LOCATION: SAN ONOFRE NUCLEAR GEN. STA., UNIT 1

P & I DIAGRAM
POST ACCIDENT SAMPLING
SYSTEM SHEET 1

CONFIGURATION CHANGE

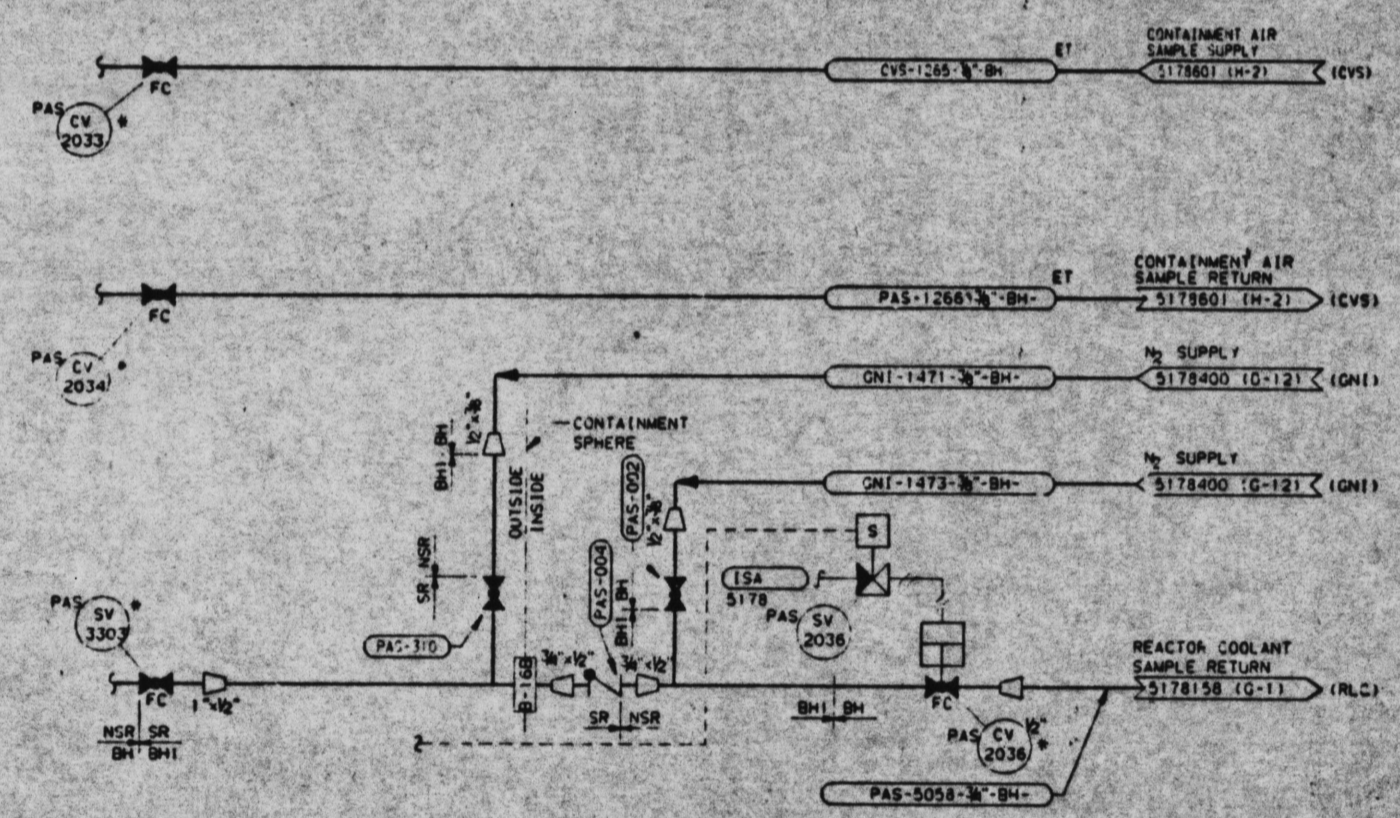
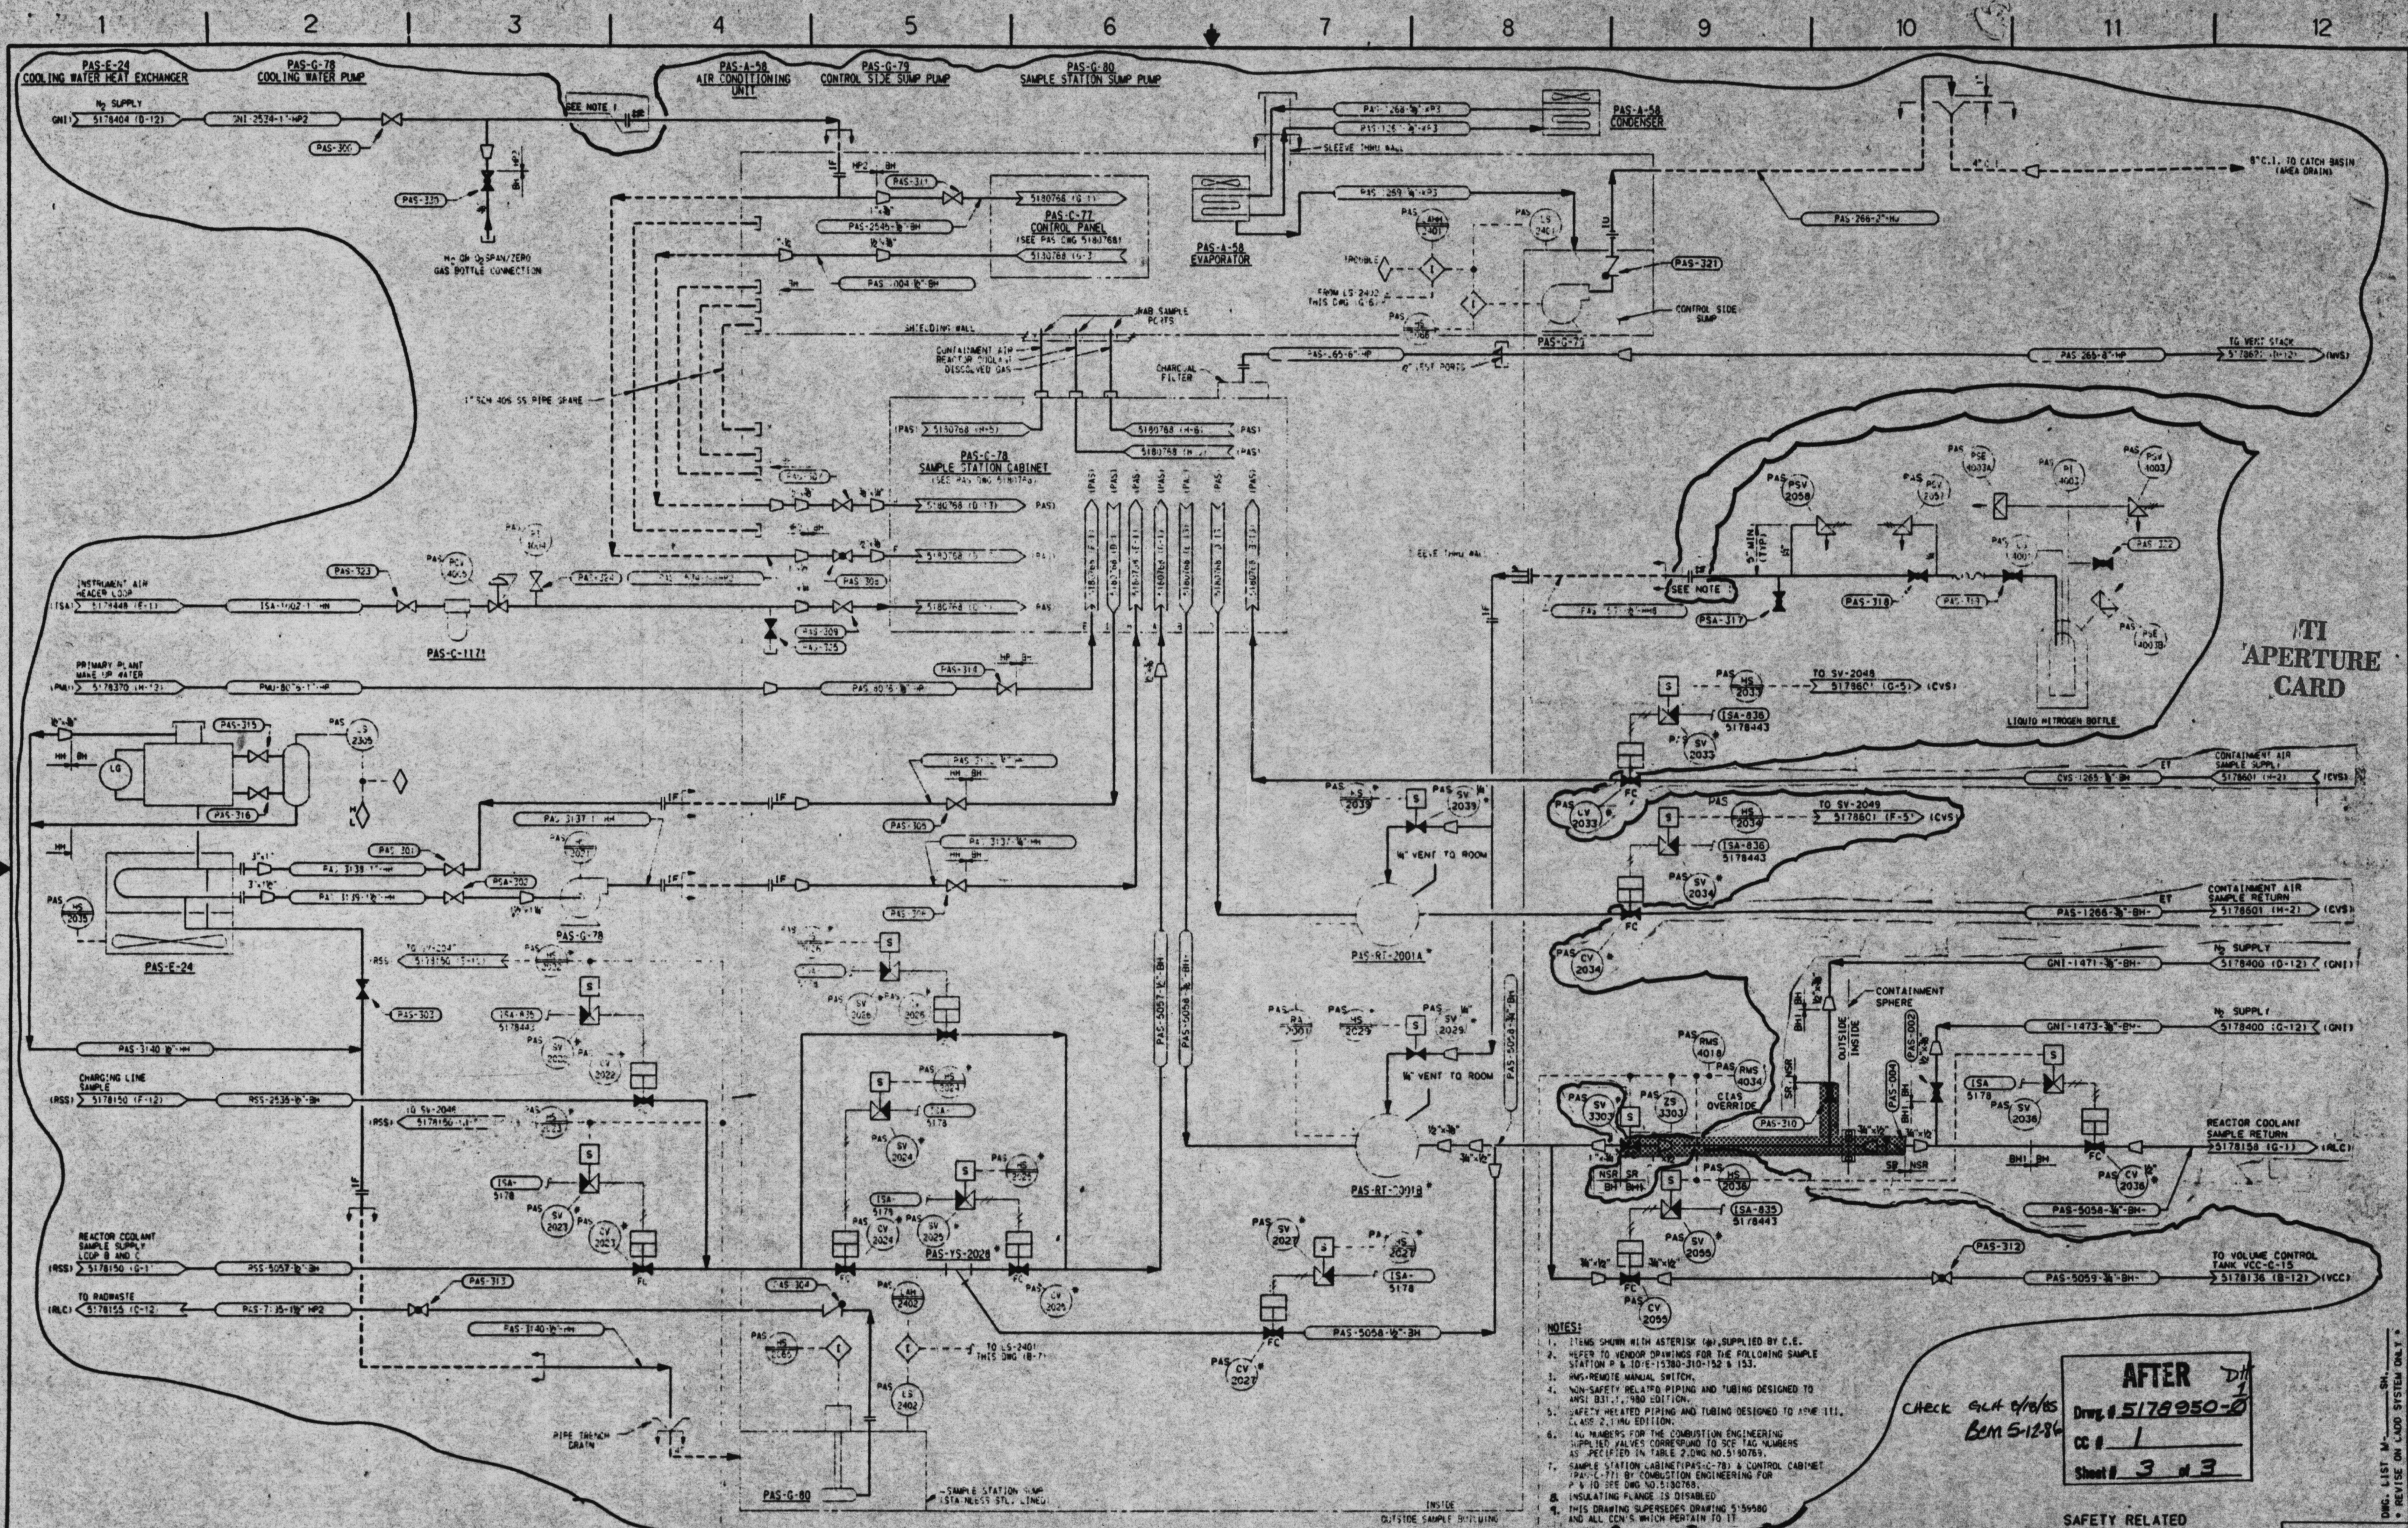
REQUESTED BY D. HADLEY	<input type="checkbox"/> SPECIFICATION <input checked="" type="checkbox"/> DRAWING <input type="checkbox"/> PROCEDURE <input type="checkbox"/> INSTRUCTION	NUMBER 5178950	REVISION B	CLASS ER
TITLE PEI DIAGRAM POST ACCIDENT SAMPLING SYSTEM SHEET 1		SUPPLIER <input type="checkbox"/> BECTEL <input checked="" type="checkbox"/> EDISON		
DESCRIPTION OF CHANGE PARTIAL 1. INCORPORATED CC'S #8, 9, 11, 13, 15 & 16 CC'S #10, 12 & 14 TO DRAWING 5159580		J.O. NO. 7764	W.G. NO.	
REF. INFO: CC'S #1, 2, 3, 4, 5, 6 & 7 CANCELED BY CC#8 CC'S #10, 12 & 14 CANCELED WP 2.1.8a				
JUSTIFICATION DRAWING #5159580 WAS REDRAWN ON THIS DRAWING PER WP 82-063				
EVALUATION				
OTHER AFFECTED DOCUMENTS / DRAWINGS: 5159580				
DOCUMENT CHANGE REQUIRED FOR: <input checked="" type="checkbox"/> CONSTRUCTION <input type="checkbox"/> AS BUILT <input type="checkbox"/> OTHER				
FIELD APPROVALS		DESIGN APPROVALS
